STAFF REPORT: 8/10/2022 REGULAR MEETING

APPLICATION NUMBER: #22-7950

ADDRESS: 2550 W. BOSTON

SCOPE: REPLACE WOOD WINDOWS WITH ALUMINUM-CLAD WOOD WINDOWS; ERECT FENCE

Fig.1 by Applicant: Jeld Wen series showing brickmold section (in red).

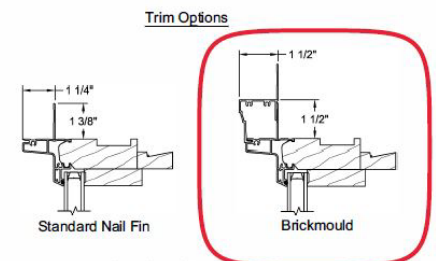
- The proposal shows that the windows would also replace the brickmold with a thick, blocky 1 1/2" vinyl coil brickmold. It is staff's opinion that removal of the original brickmold and this replacement are inappropriate.
